## ***McClellan Nuclear Radiation Center***

Reference: University of California, Davis, McClellan Nuclear Radiation Center (UCD/MNRC),  
Docket No. 50-607, Facility Operating License No. R-130

TECHNICAL SPECIFICATIONS  
FOR THE  
UNIVERSITY OF CALIFORNIA - DAVIS MCCLELLAN NUCLEAR RADIATION CENTER  
(UCD/MNRC)

DOCUMENT NUMBER: MNRC-0004-DOC-11

UCD/MNRC ORGANIZATION FOR LICENSING AND OPERATION  
FIGURE 6.1

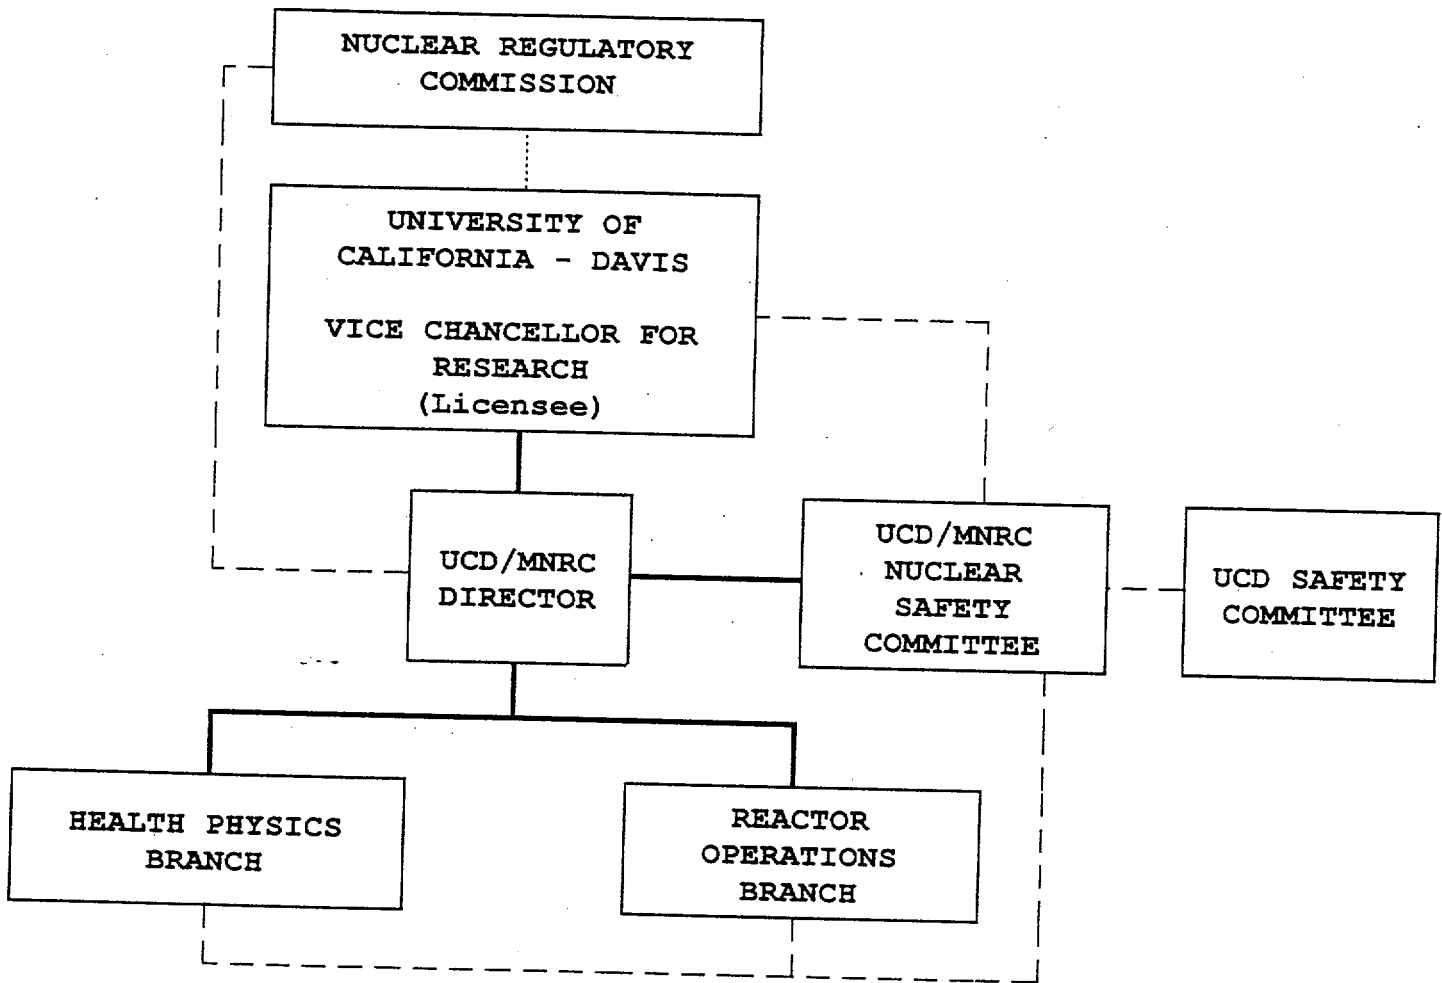
5. Section 6.0: This section has numerous text changes to reflect the new licensee. In addition, there is a new Figure 6.1, Organization for Licensing and Operation, which incorporates administrative units of the new licensee. Section 6.2 has been changed slightly to reflect the organization and duties of the Nuclear Safety Committee (NSC), and to clarify the Committee's review and audit functions. Subsection 6.6.2 was changed slightly to clarify the NSC's role in the event of a reportable occurrence.

6.1.1 Structure. The management for operation of the UCD/MNRC facility shall consist of the organizational structure as shown in Figure 6.1.
